LYDEN AVE., PEAKS ISLAND

RE: 115 Lyndon Avenue, Peaks Island, Maine

Your application to make exterior renovations, roof and enclosed porch, has been reviewed and a permit is herewith issued subject to the following requirement:

Details for proposed repair and improvements of 115 Lyndon Ave., Peaks Island, Portland ME.

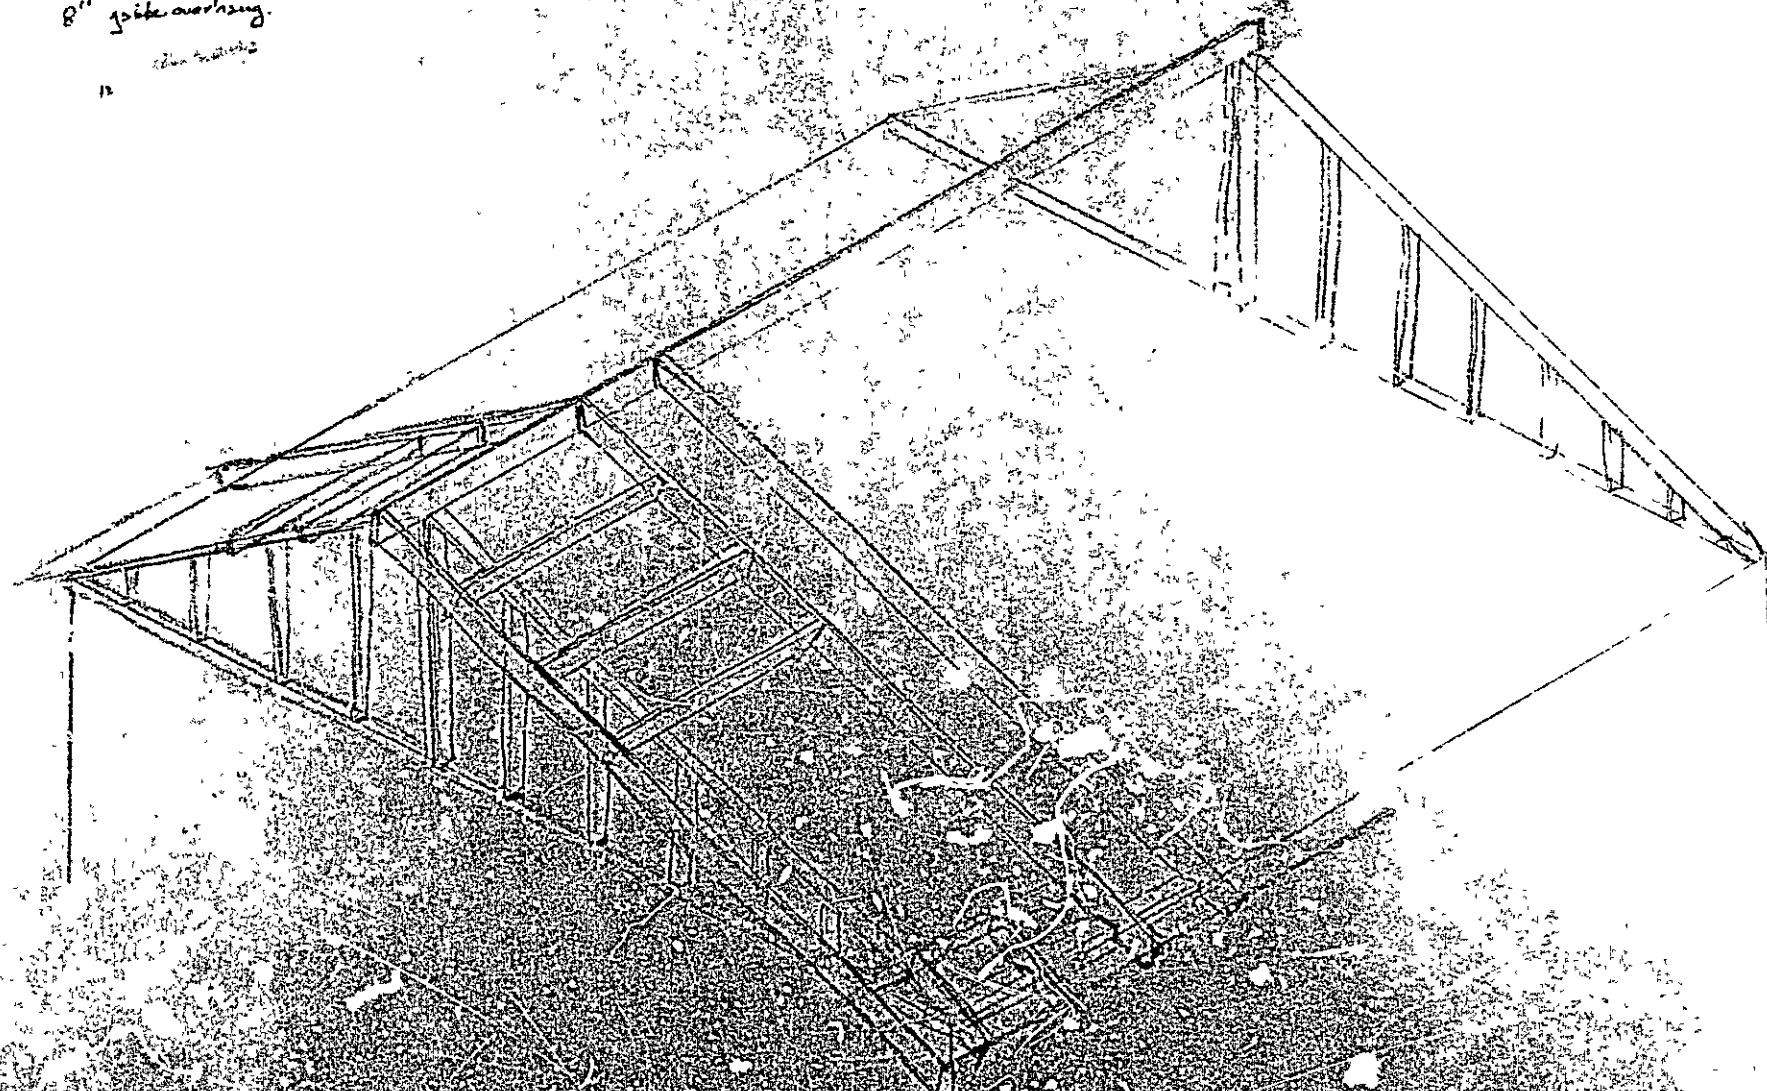
Your plans show 2" X 6" rafters 16" c.c. spanning 12'. 2" X 6", 16" c.c. spanning 12' will not support the live load of 50 PSI. Therefore, a minimum of 2" X 8", 16" c.c. must be used for this application.
